What we heard...

March Meeting - Marlborough Street Concept

397 COMMONWEALTH AVE

Proposed Views - Marlborough Street

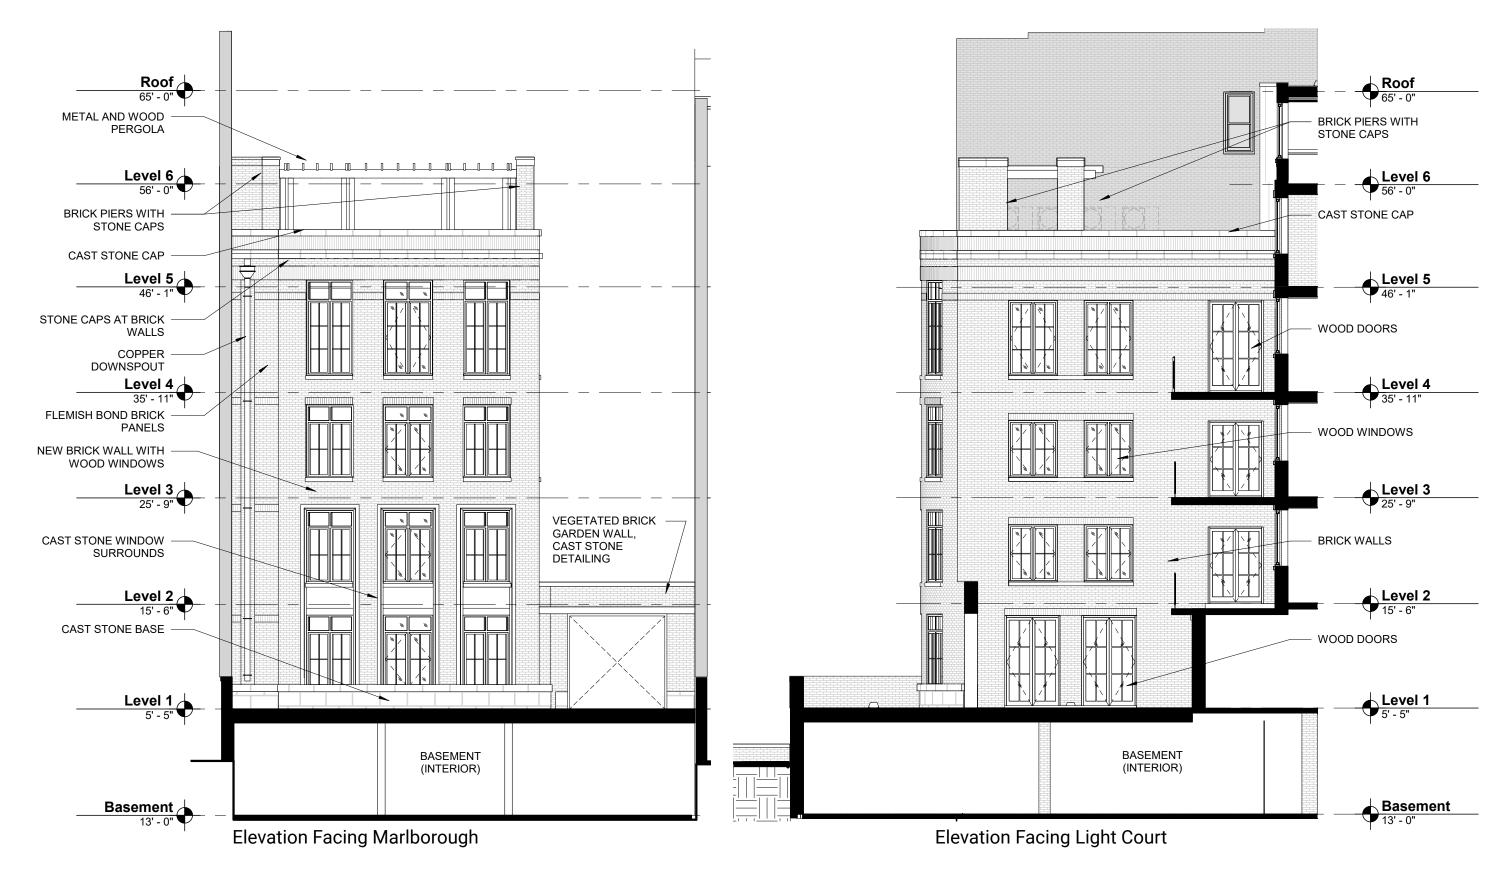
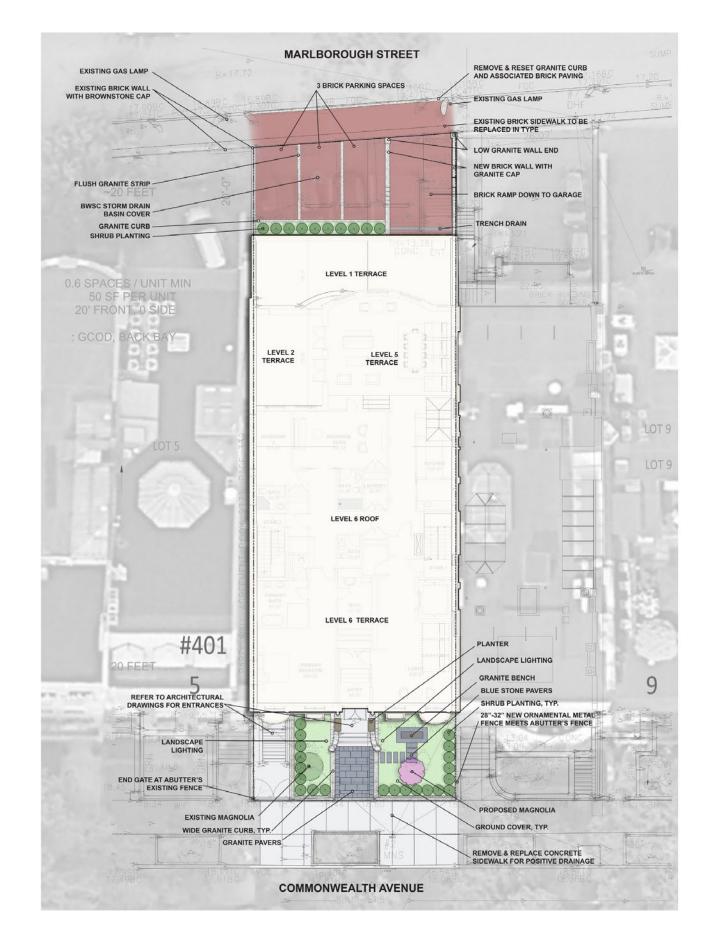
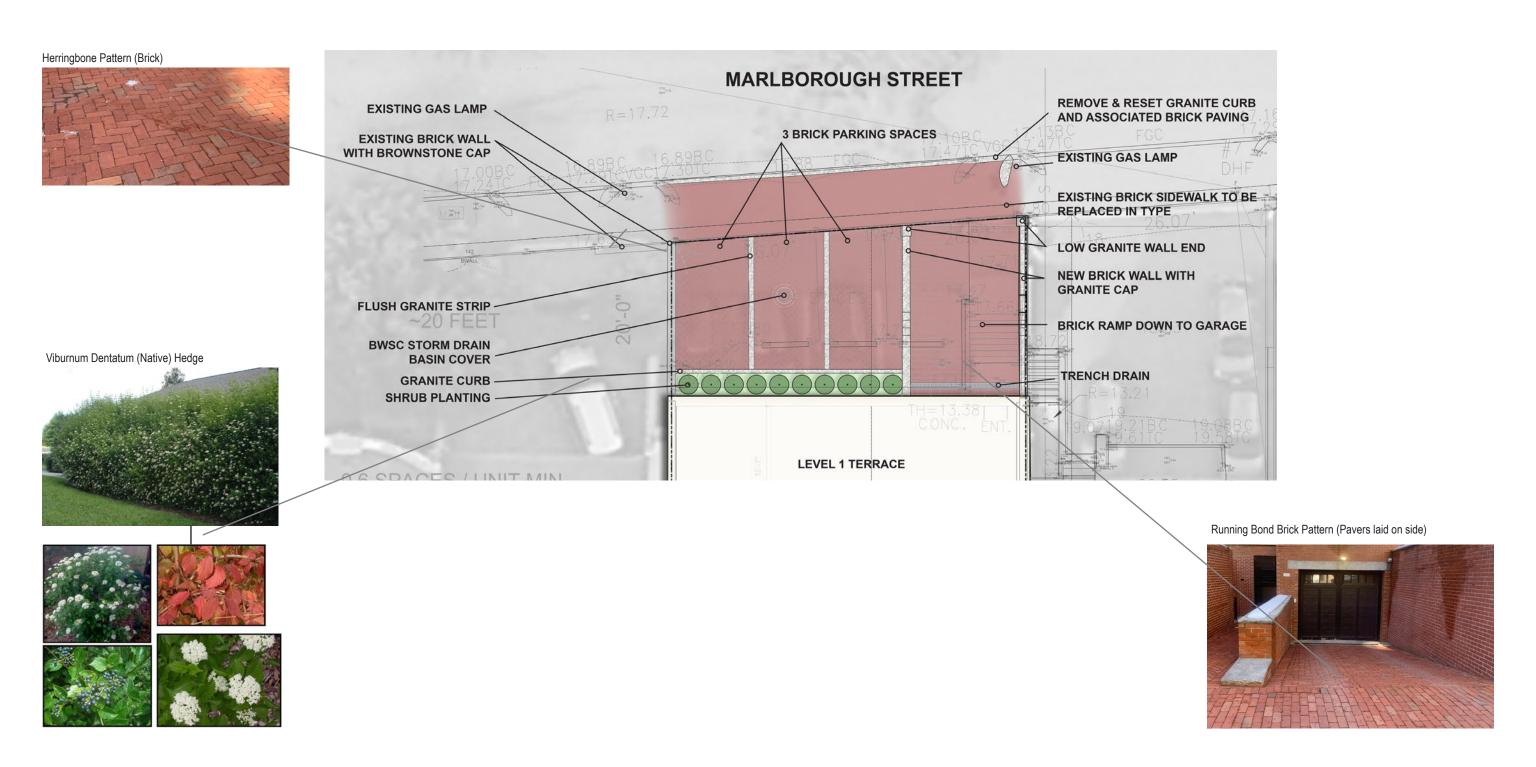
Openings feel like windows are missing; too much sky visible through them.

Additional height is helpful, but expression does not feel right - consider alternatives.

Addition height should approxmiate the window sill of the adjacent building's top floor.
